V-5 Errata

Regretfully, a number of inaccuracies appear in the Owner's Manual for Roland Video mix/Title Processor V-5. It should read as shown below. We apologize for any inconvenience this may cause.

Page 77 – Page 78, “Revising the time set in the program” Step 10

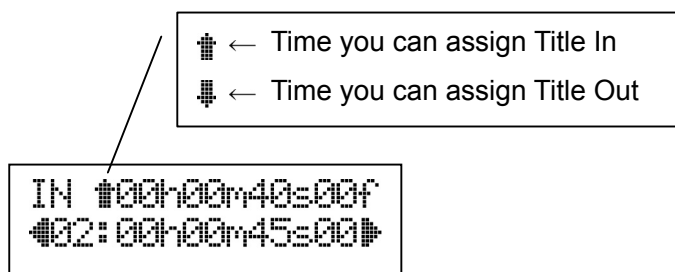
- * If you play back the video normally, title in/out will be executed at the assigned time.
- * If you play back the video in special ways such as frame-by frame, slow, or picture search FF/REW in the pause status, title in/out will not be executed at the assigned time.

If the current time of the video tape which is running is before the assigned time for title in/out, you can revise the assigned time by pressing [TITLE IN] or [TITLE OUT] button, and title in/out will be executed.

If you wish to revise the title in/out time after it is executed, please follow the procedure below.

- (1) Pause the video.
- (2) Press [<] button four times to go back to the page to assign the time for last-executed title in/out.
- (3) Search the time of the video you wish to re-assign by playing back in special ways such as frame-by-frame, slow, etc.
- (4) Press [TITLE IN] or [TITLE OUT] button. Title in/out time is revised and executed.
- (5) If you wish to revise again, repeat the above steps (1) to (4).

* At the time you can assign the title in/out, following sign appears at the left of the time code in the upper line in the display. If this sign does not appear, you can not assign even if you press [TITLE IN] or [TITLE OUT] button.
